Subdivision and Land Development Cover
Page for SLD # 10-21

Project Name: Leo Brown Group o/b/o
Sabra Healthcare

Address: 251 Stenton Avenue

Reference: Sketch Plan Review
251 Stenton Avenue – Sabra Healthcare
Whitemarsh Township, Montgomery County, Pennsylvania
SLD #10-21

SHEET TITLE
CONCEPT PLAN 'A'

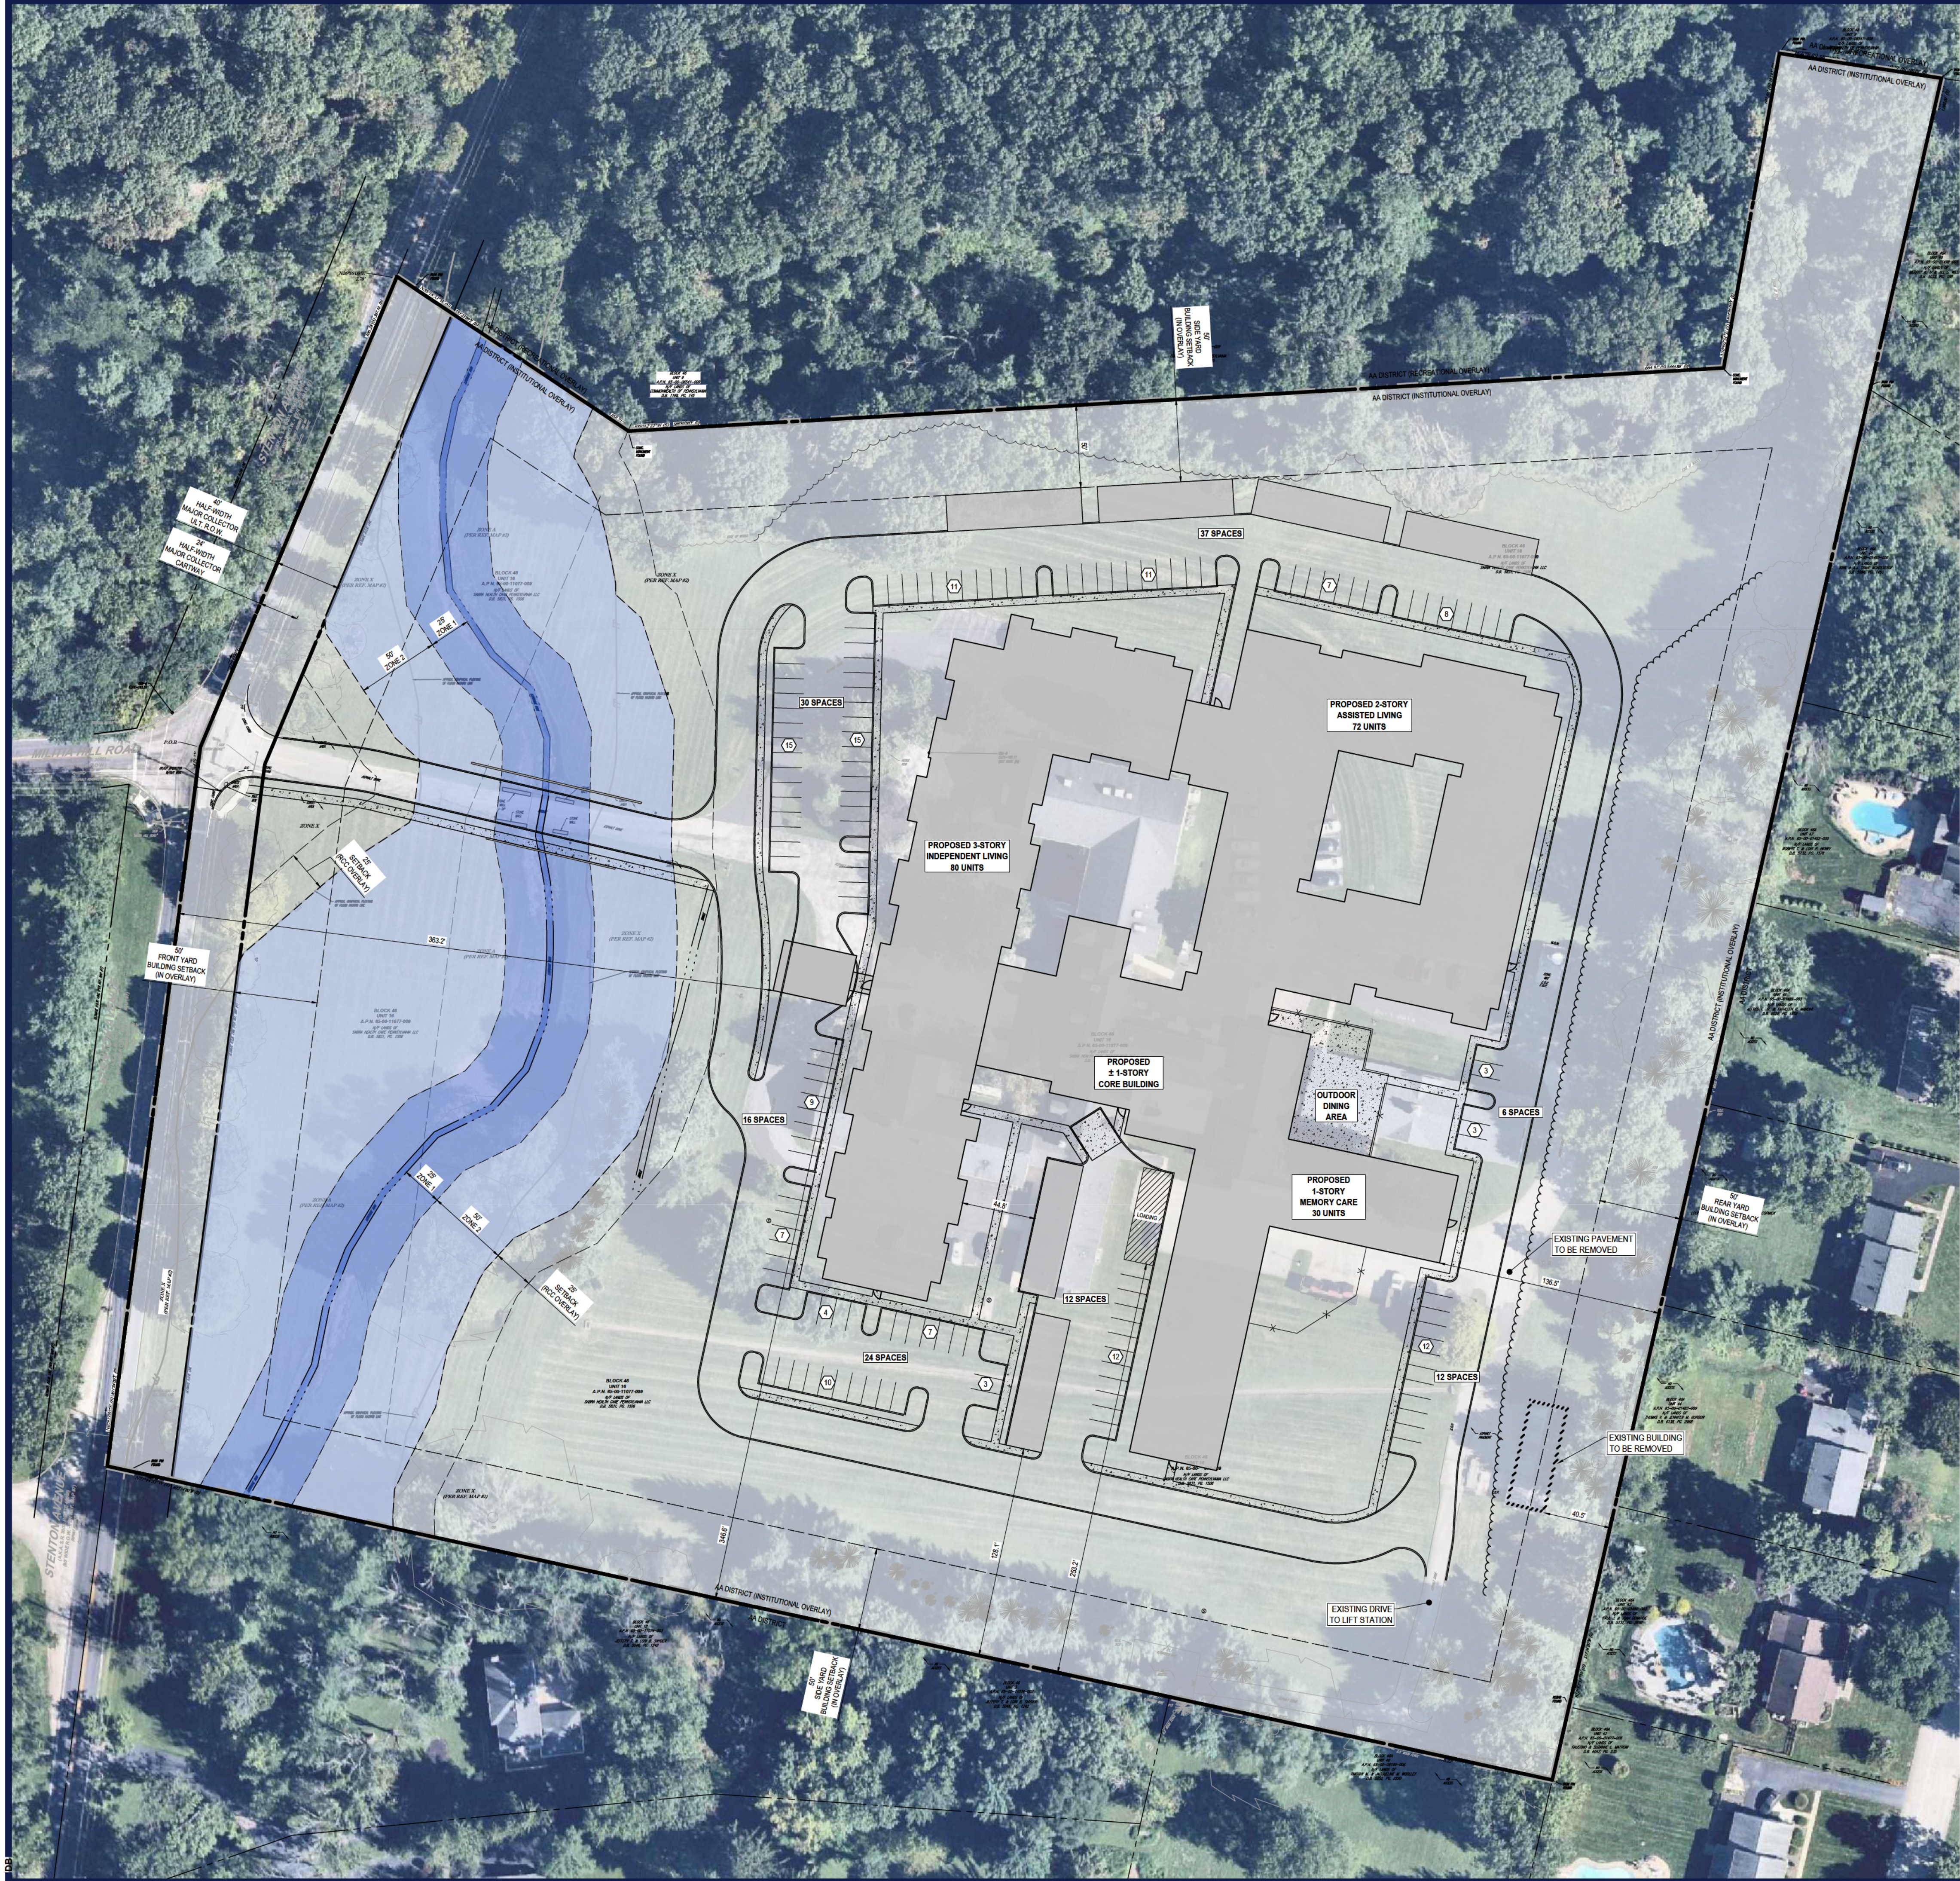
The applicant’s text amendment is accompanied by a sketch plan entitled Concept Plan ‘A’ that proposes the redevelopment of the Fox Nursing Home, which is on a 16.48 acre lot. The subject property is Tax Parcel 65-00-11077-00-9, a lot located in the AA- Residential District and in multiple overlay districts including: the Institutional Overlay, the Floodplain Conservation Overlay, the Riparian Corridor Overlay District, and the Steep Slope Overlay Zoning Districts.

The sketch plan proposes the construction of several senior-residential buildings including: a 3-story, 80-unit, independent living building; a 2-story 72-unit assisted living building; a 1-story, 30-unit memory care building; and a +/- 1-story core building. It appears from the aerial overlay that much, if not all of the existing 47,000 sq. ft. Fox Nursing Home will be demolished. Access to the facility is currently from an access driveway at the intersection of Militia Hill Road and Stenton Avenue. The access drive crosses over the Lorraine Run and its riparian corridor using a bridge which spans +/- 80 ft.

The sketch plan's driveway and parking lot arrangement appear to show a significant increase in the impervious coverage to support the facility. We encourage the applicant to examine ways to reduce redundancy of driveway aisles and minimize widths of access driveways as a means to limit the increase in impervious coverage of the site.

CONCEPT PLAN 'A'

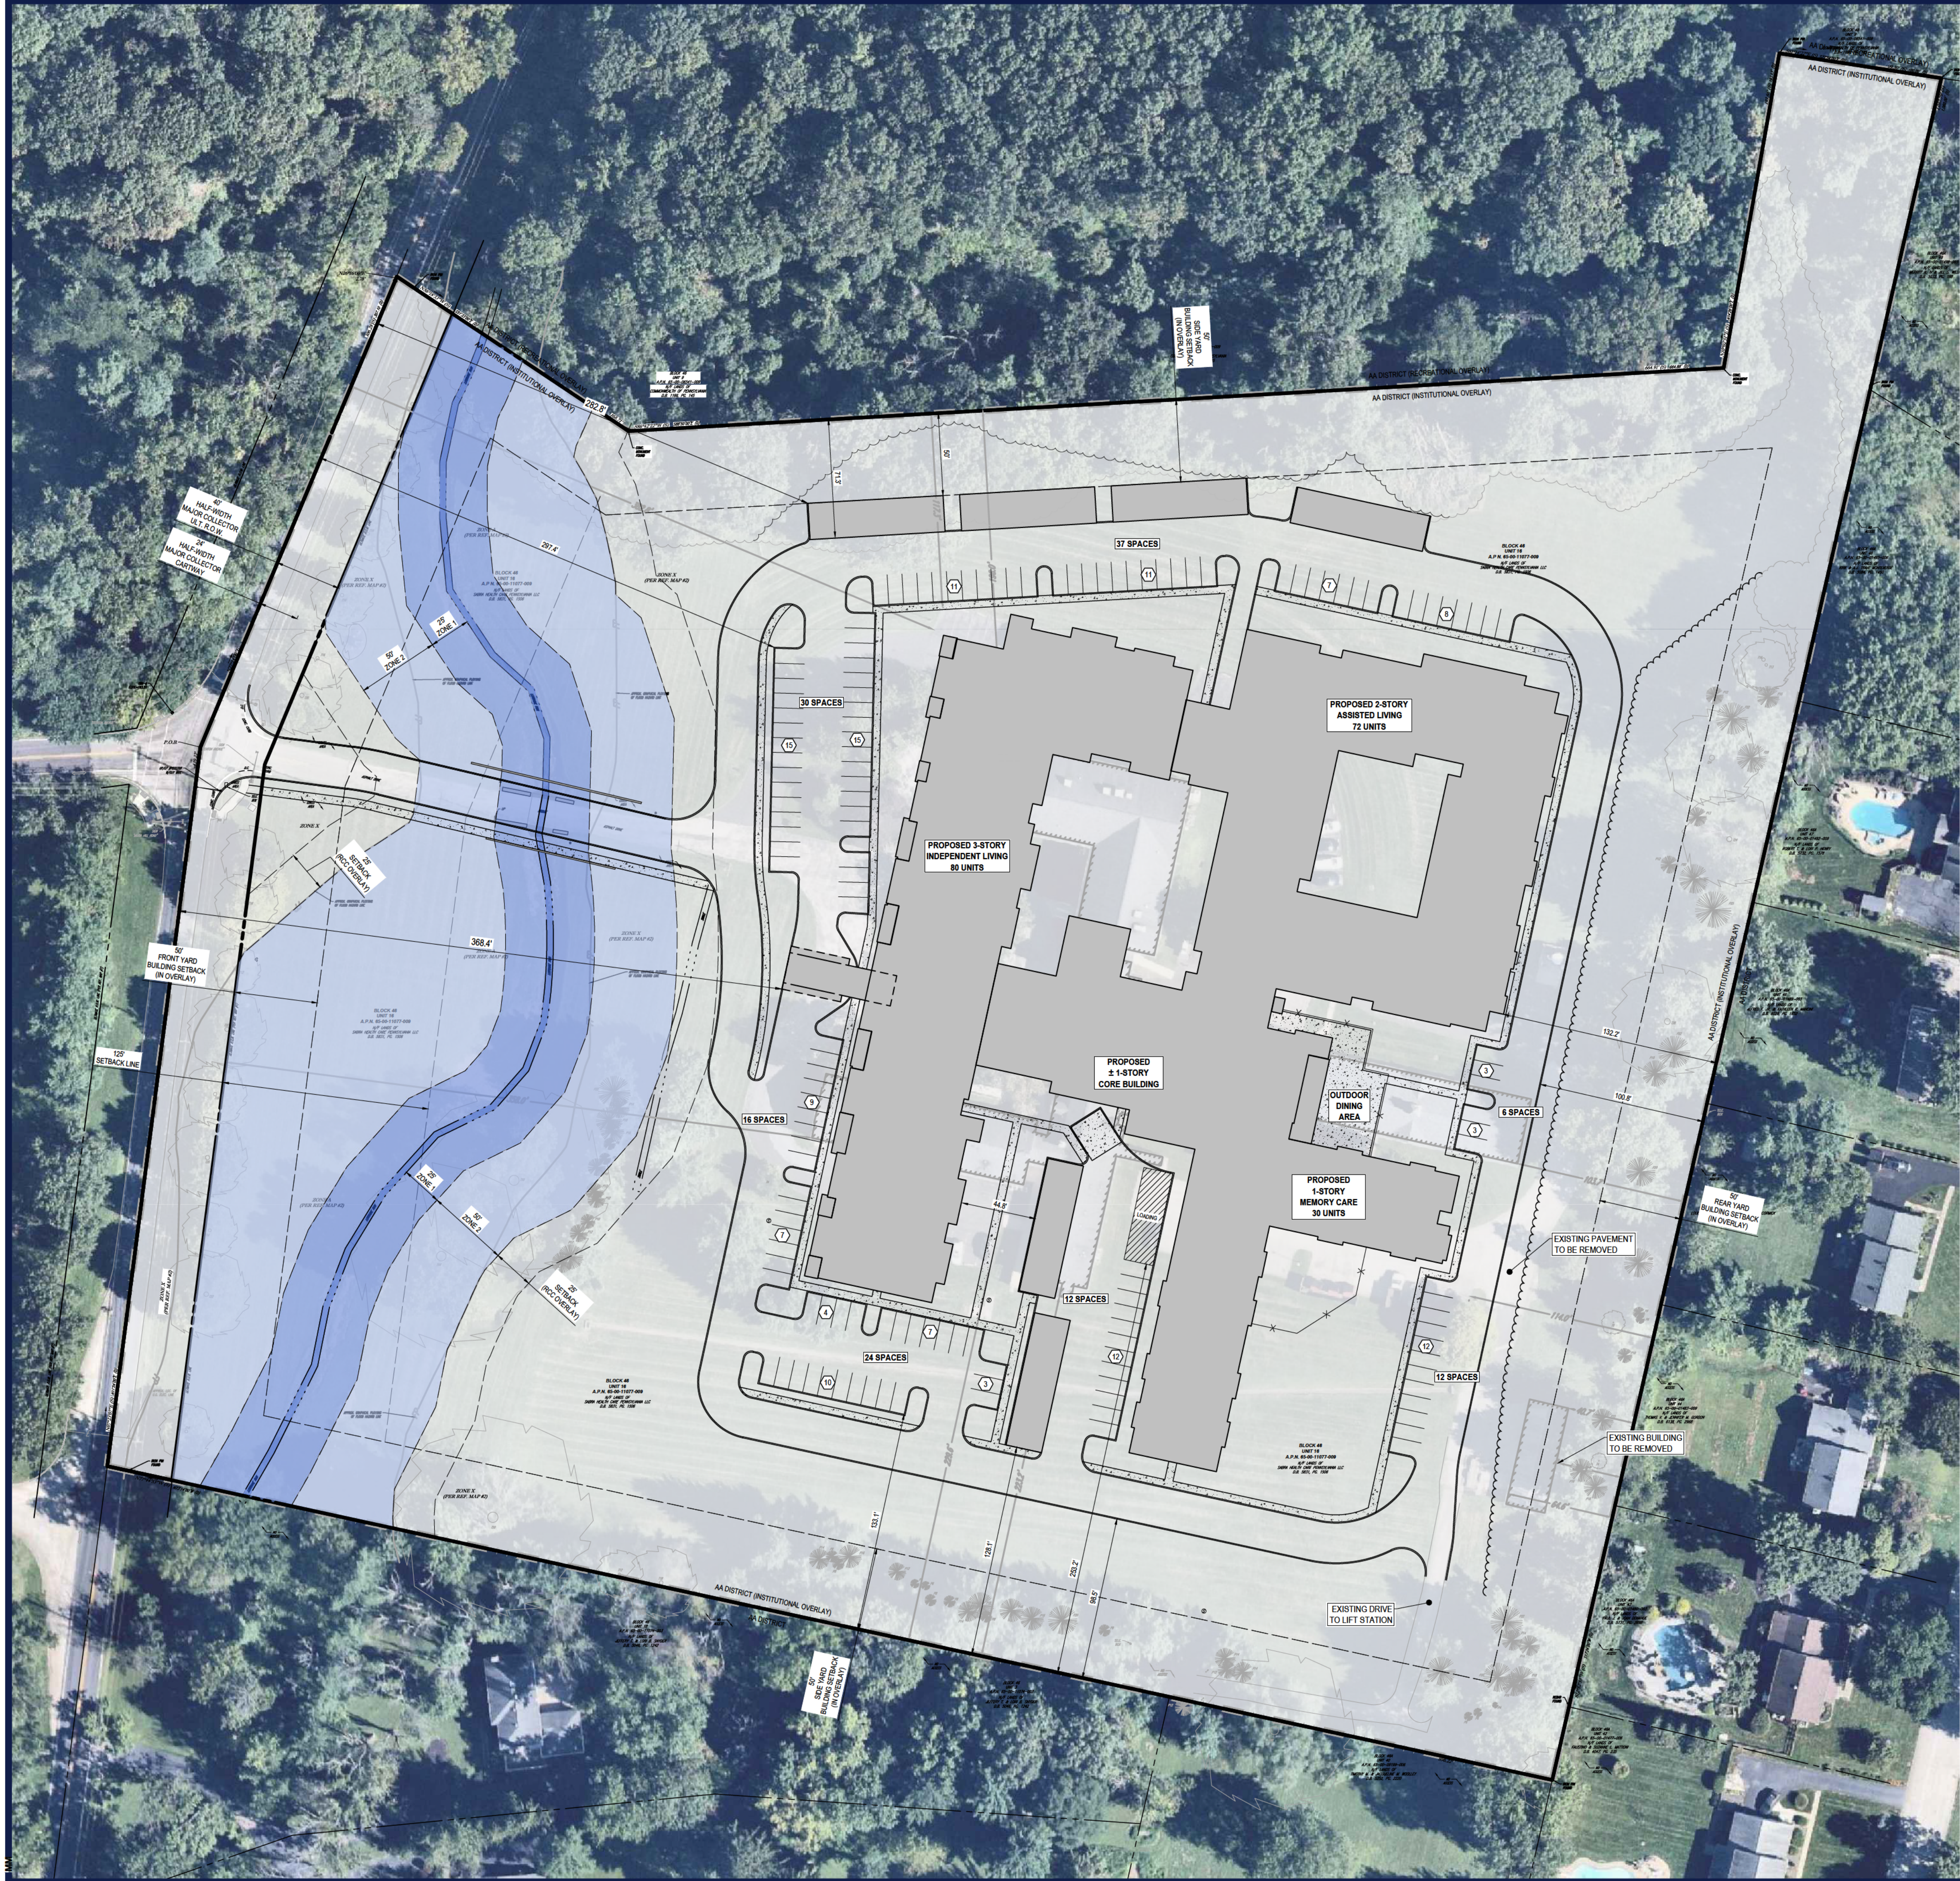
As requested, we have reviewed plans for the above referenced Sketch Plan, prepared by Bohler, dated February 18, 2021, and last revised January 6, 2022. The current plan submission was submitted in support of a proposed Zoning Ordinance Text Amendment. For the purposes of this review, the plan was reviewed as a Sketch Plan; the purpose of which is to afford the applicant the opportunity to consult early and informally with both the Planning Commission before the preparation of the preliminary plan and formal application for approval. During the sketch plan procedure, the applicant can advantageously make use of the services of the Planning Commission and Township Staff to help analyze the problem of the development and plan more adequately for its sound coordination with the community. The sketch plan procedure also affords the opportunity to give informal guidance to the applicant at a stage when potential points of difference can be more easily resolved. The following comments are offered for your consideration:

<u>Section</u>	<u>Description</u>
1. 105-20(A)(5)	The plans must be revised to include a location map showing relation of site to adjoining properties and streets within 1,000 feet. (Scale: one-inch equals 800 feet.)
2. 105-20(A)(12)	The plans must be revised to show existing principal buildings (and their respective uses) and driveways on the peripheral strip. Sewer lines, storm drains, culverts, bridges, utility easements, quarries, railroads, and other significant man-made features within 500 feet of and within the site, including properties across streets.

| 11. 105-37 | The plans must be revised to demonstrate compliance with the sight distance requirements of this section of the ordinance and/or the required sight distances contained in the most current revision of Pennsylvania Code Title 67 Chapter 441, whichever is more restrictive. |
| 12. 105-38(A) | This section of the ordinance requires that two-way aisles for parking spaces having a 90-degree angle of parking must be 24 feet wide, and a minimum parking stall width of 9 ft x 18 ft. The plans must be revised to include dimensions for parking areas, in order to demonstrate compliance with the requirements of this section of the ordinance. |
| 13. 105-38(C) | This section of the ordinance requires curves/turns in entrance and exit drives and all internal parking lot aisles necessary for providing access for fire protection equipment to have a minimum inside turning radius of 25 feet and a minimum outside turning radius of 50 feet. The applicant shall submit plans using truck turning templates showing the required turning radii are provided for access to each building. |
| 14. 105-38(K) | This section of the ordinance requires that parking lots with more than 30 spaces not have grades that exceed 3%. The plans must be revised to provide parking area grades in compliance with the requirements of this section of the ordinance. |
| 15. 105-38(O) | Parking areas shall be located at least 10 feet from any building or structure. The plans must be revised to include dimensions for parking areas, in order to demonstrate compliance with the requirements of this section of the ordinance. |
